GS#610-012 MCM LeFleur's Bluff Park Improvements (Phase 1B)
Mississippi Department of Wildlife, Fisheries, and Parks

ADDENDUM NO. 02

E0.0
ELECTRICAL LEGEND

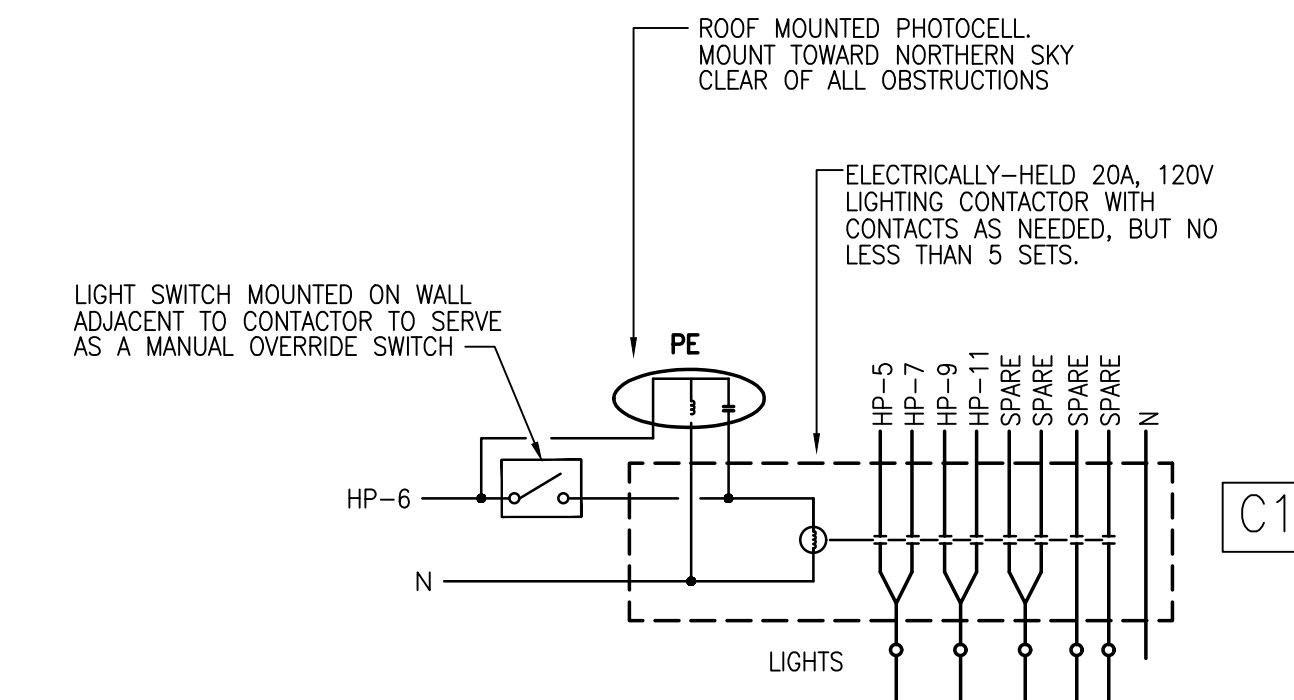
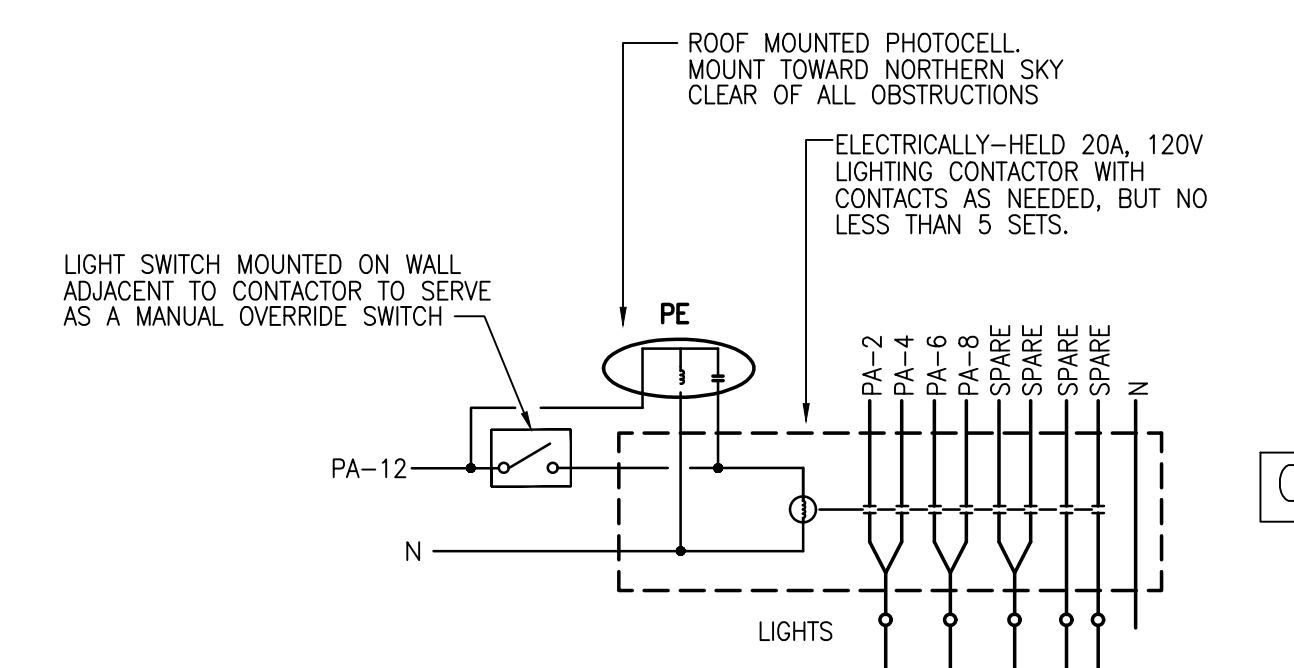
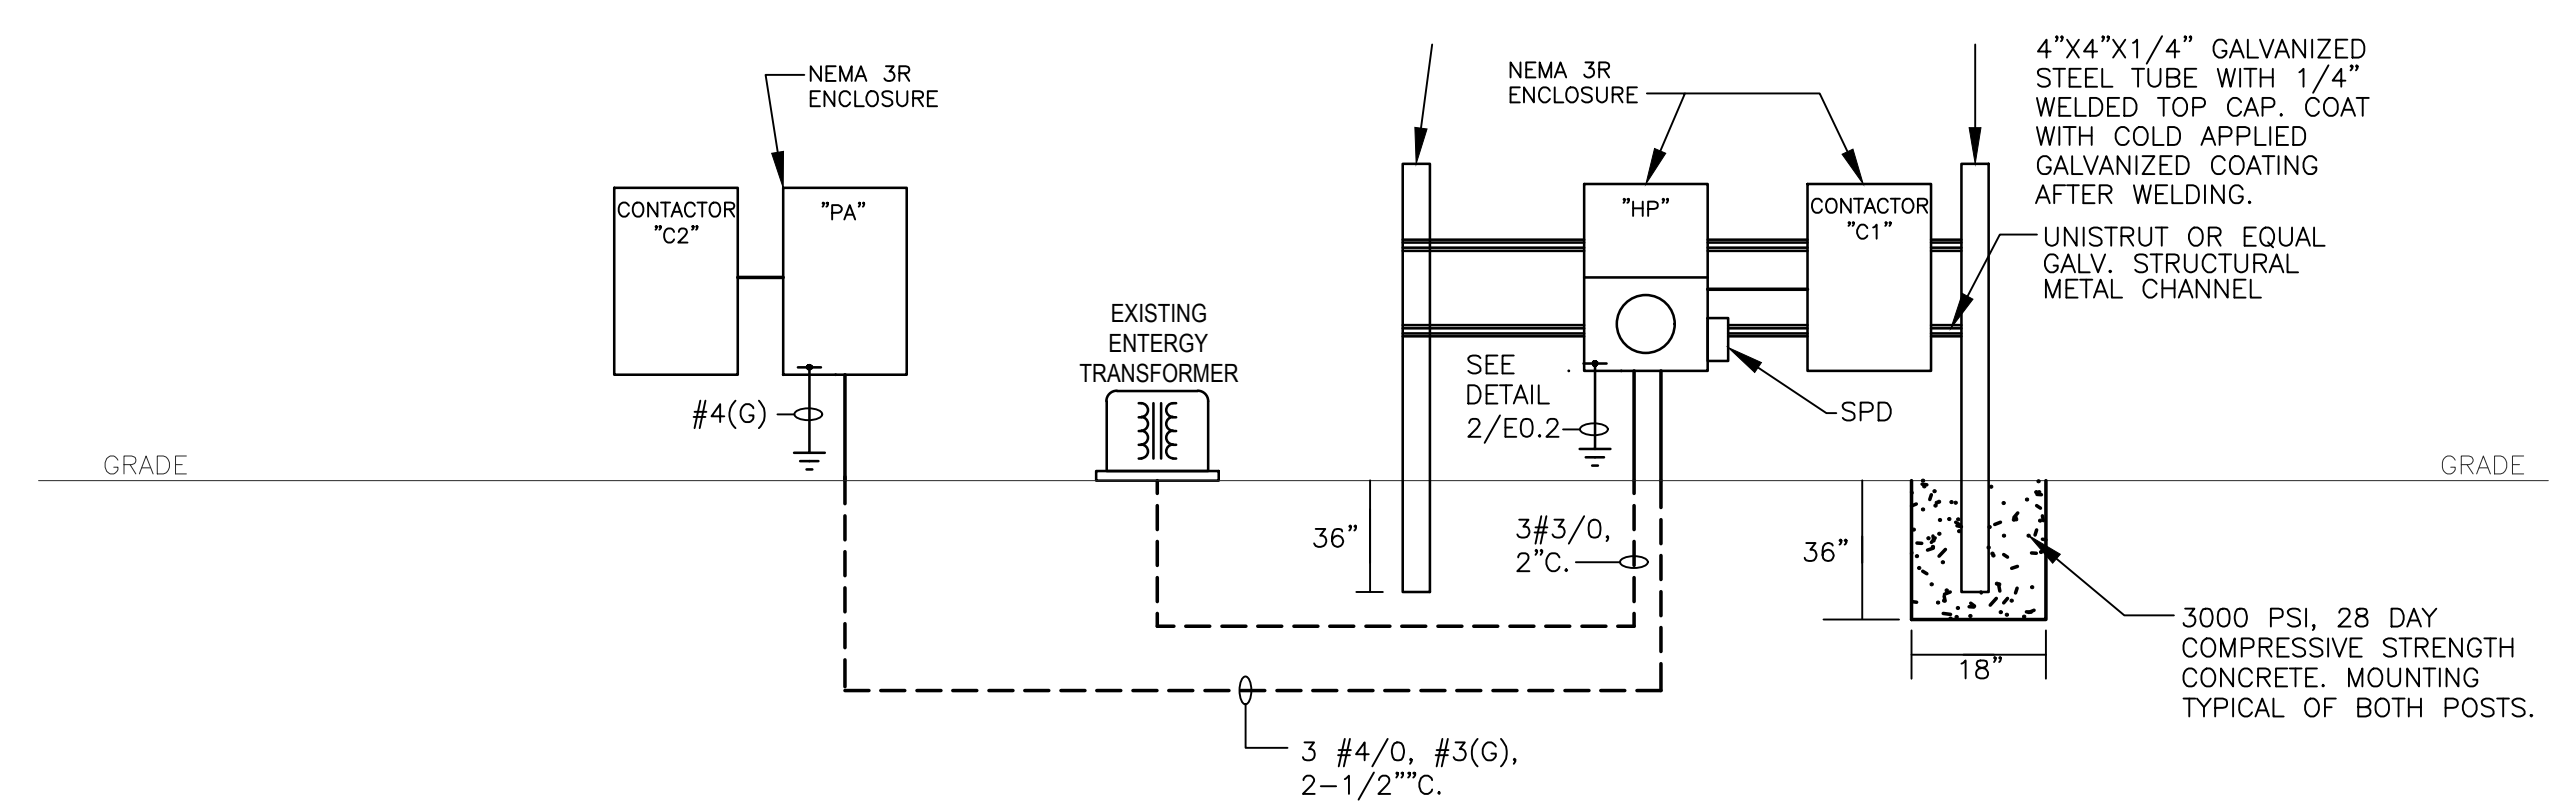
- ITEM NO. 05** **E0.0 – Electrical Legend – Electrical**
REPLACE sheet with the attached **E0.0**.
Adds pole mounted receptacles to panel schedule.

① **RENOVATION SITE PLAN - 1B**
 E1.1 Scale: 1" = 60'-0"

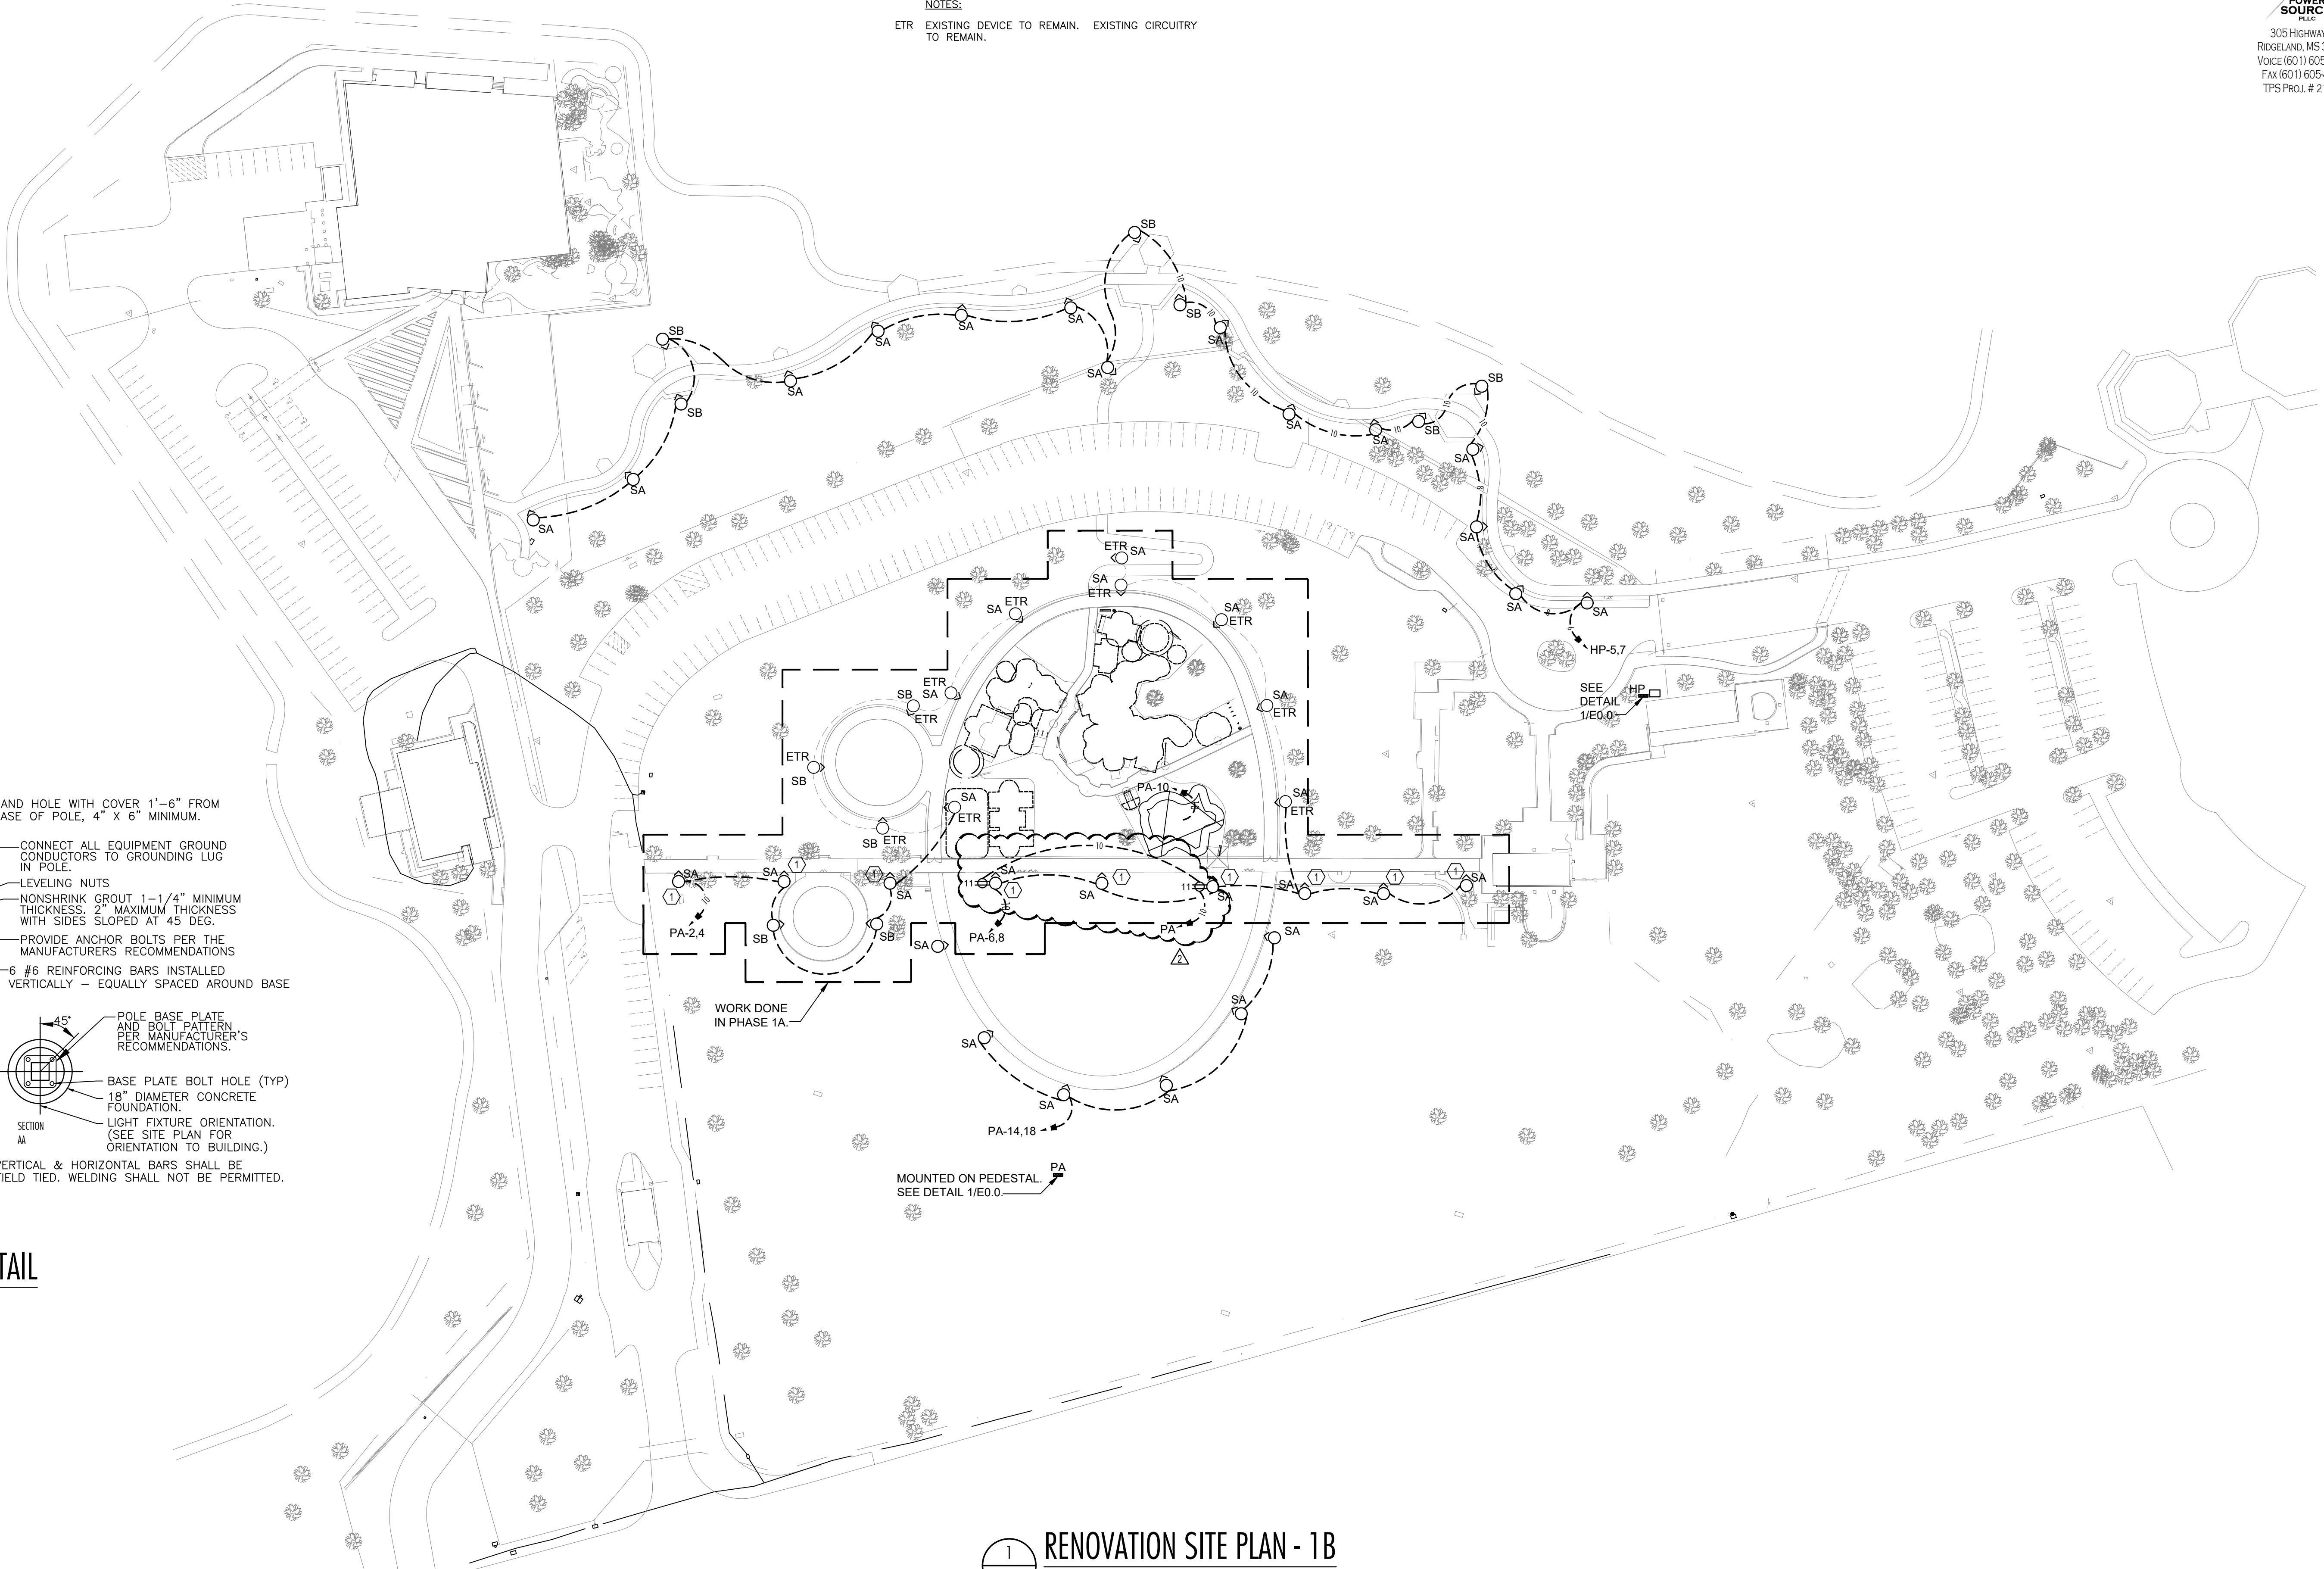
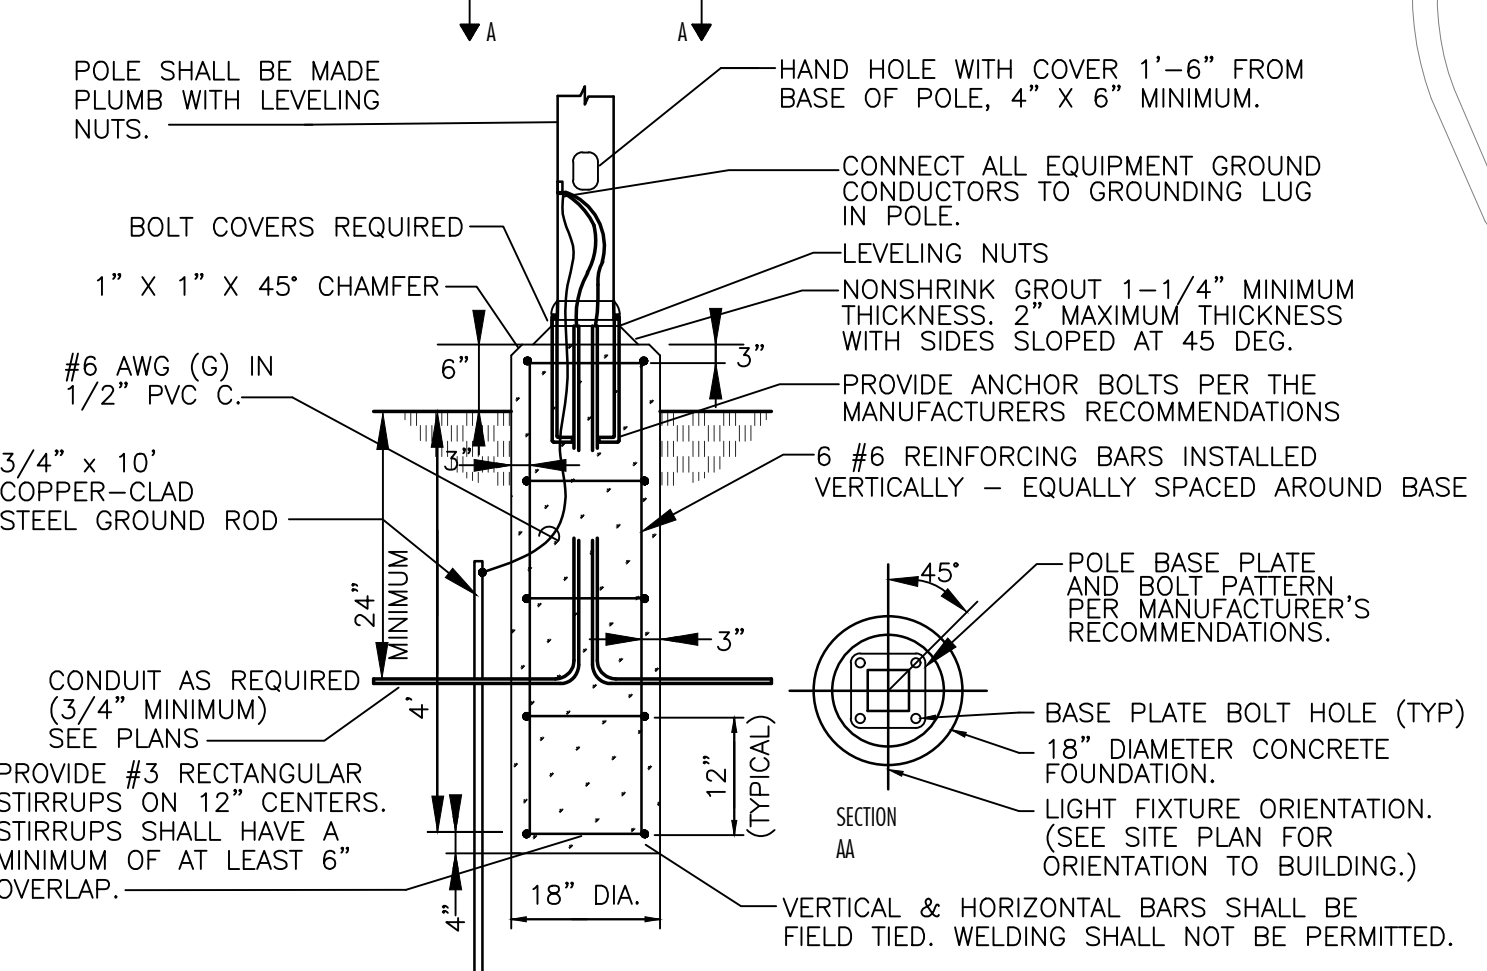
ITEM NO. 06 **E1.1 – Renovation Site Plan – 1B – Electrical**
REPLACE sheet with the attached **E1.1.**
Adds pole mounted receptacles to scope of work.
